# SERVICE BULLETIN

## Replacement of circlip (carburetor) for ROTAX® Engine Type 912 and 914 (Series)

ATA System: 73-00-00 Fuel system

**MANDATORY**

Fig. 5

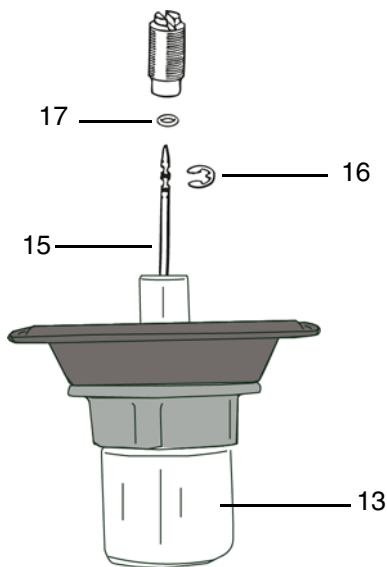
Step	Procedure
6	Remove jet needle (15) with circlip and O-ring from piston assy. (13).
7	Remove original O-ring (17) and circlip (16) from the jet needle (15) and discard. NOTE: Take note of the circlip's original needle position.

Fig. 6

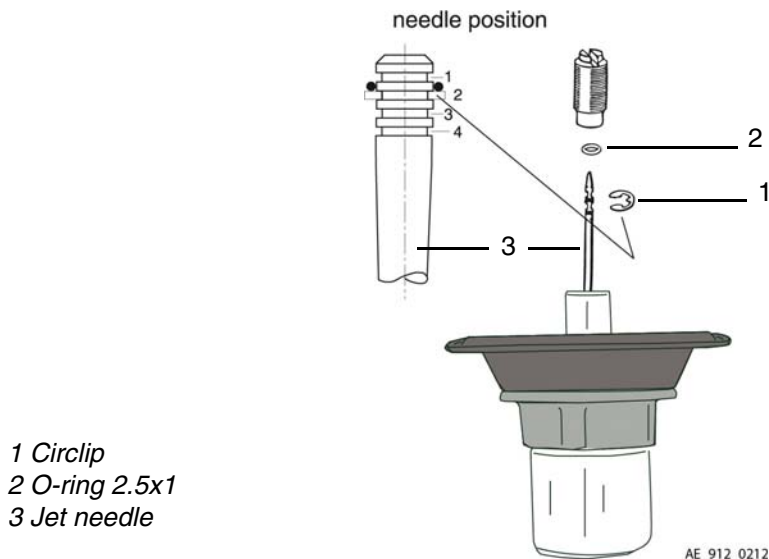
Step	Procedure
1	Place a new circlip part no. 945786 (1) into the same needle position. Place a new O-ring 2.5x1 part no. 950430 (2) over the jet needle (3).
